Subject: AP1000 COL Response to Requests for Additional Information (TR 9)

In support of Combined License application pre-application activities, Westinghouse is submitting responses to the NRC requests for additional information (RAIs) on AP1000 Standard Combined License Technical Report 9, APP-GW-GLR-005, Containment Vessel Design Adjacent to Large Penetrations. These RAI responses are submitted as part of the NuStart Bellefonte COL Project (NRC Project Number 740). The information included in the responses is generic and is expected to apply to all COL applications referencing the AP1000 Design Certification.

Responses are provided for RAI-TR09-001 through RAI-TR09-008, transmitted in NRC letter dated May 18, 2007 from Mike Miernicki to Andrea Sterdis, Subject: Westinghouse AP1000 Combined License Pre-Application Technical Report 9 – Request for Additional Information (TAC NO. MD1847). These responses complete all requests received to date for Technical Report 9

Figure 3.8.2-4 (Sheet 2 of 6)
Containment Penetrations Startup Feedwater

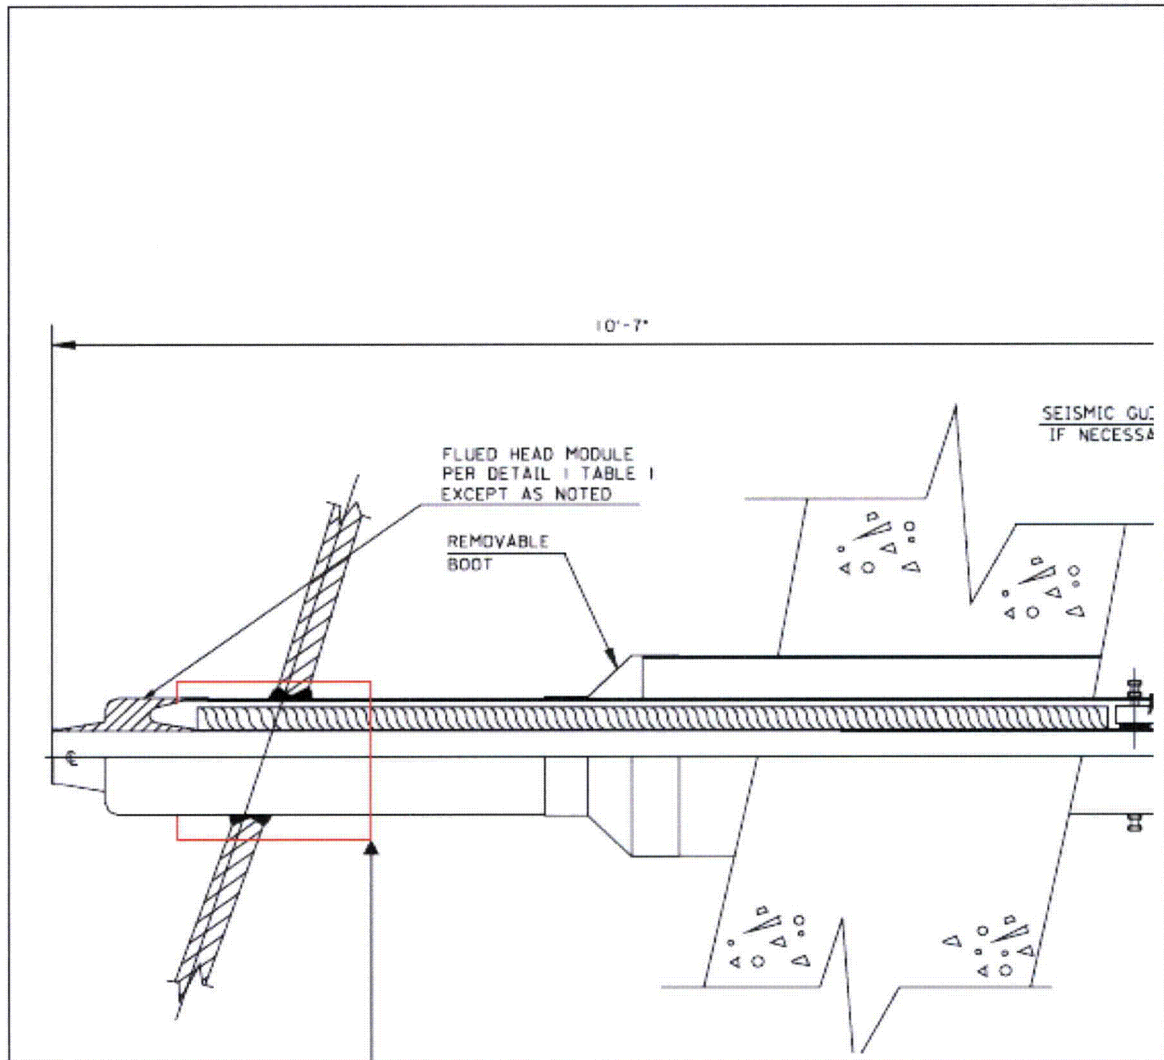
There are no design details for the penetrations in TR-9. The staff requests the applicant to include design information (geometry, material and material properties, dimensions and wall thicknesses) for each penetration in TR-9. Also specify the ASME Code, Class MC jurisdictional boundaries for each penetration.

Revise sheets 2, 3, 4 and 6 of Figure 3.8.2-4 as shown on the following pages to reflect detail design of the penetration reinforcement.

Thicken nozzle and add weld to
guard pipe outside containment.
